UNITED STATES PATENT AND TRADEMARK OFFICE

APPLICATION NO.	FILING DATE	FIRST NAMED INVENTOR	ATTORNEY DOCKET NO.	CONFIRMATION NO.
10/804,743	03/19/2004	Paul S. Lin	26874/04013	8272

Office Action Summary

DETAILED ACTION

FIG. 3

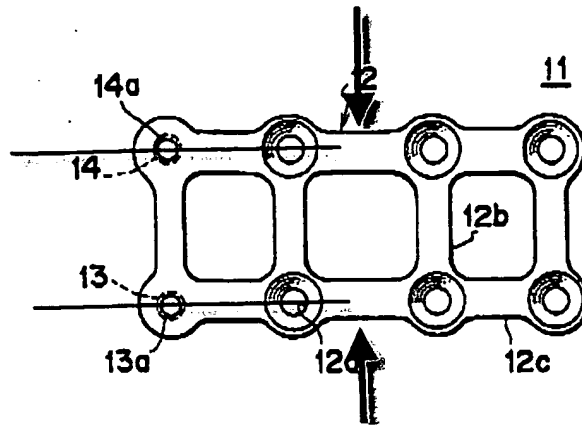
Maruyama discloses a plate with apertures for screws, and is defined along a single axis (as presented in office action dated 2/8/06 and below), a cleat (3, 4), an interior and exterior faces, a central portion with reduced width, a second cleat, a plate with a bowed width. Maruyama discloses the claimed invention except for having a slot

Applicant argues that none of the prior art discloses having apertures along a single axis and that one is a slot. It is clearly shown in the modified figure 3 above that the apertures are along a single axis (or look at figure 2, Maruyama). In regards to the slot, Warden clearly shows a slot (30) to allow the surgeon ease of inserting the screw. This argument is found not persuasive.

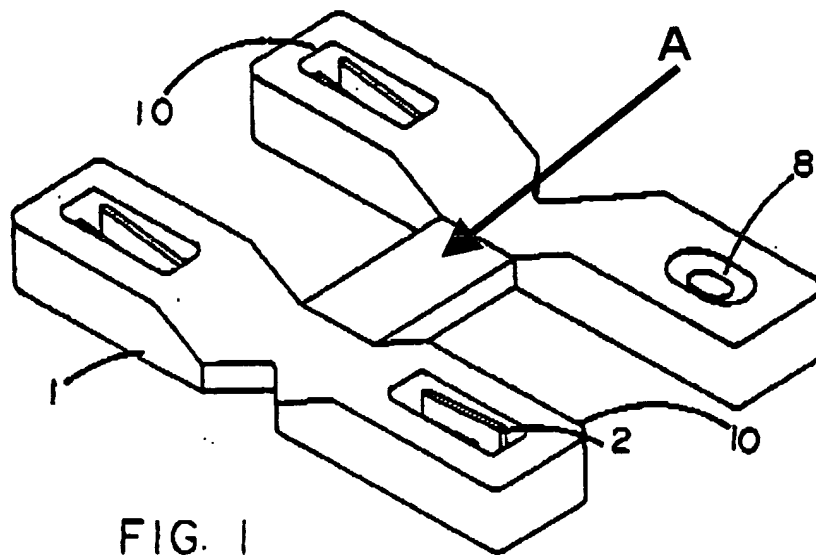
The combination of Maruyama and Warden discloses the claimed invention except for having cancellous screws and a center beam. Aust discloses a plate with cancellous screws (col 3: 7-12) (claim 8) and a centerline beam (A, in modified figure below, and discussed in office action dated 2/8/06) (claim 11). This allows the plate to be firmly attached to the bone (col 2: 51-58) (claim 7 and 8) and improves the structural stability of the plate. It would have been obvious to one skill in the art at the time the invention was made to construct the plate of the combination of Maruyama and Warden with cancellous screws and a centerline beam in view of Aust, in order to prevent the plate from being loosened from the bone and provide structural stability to the plate.
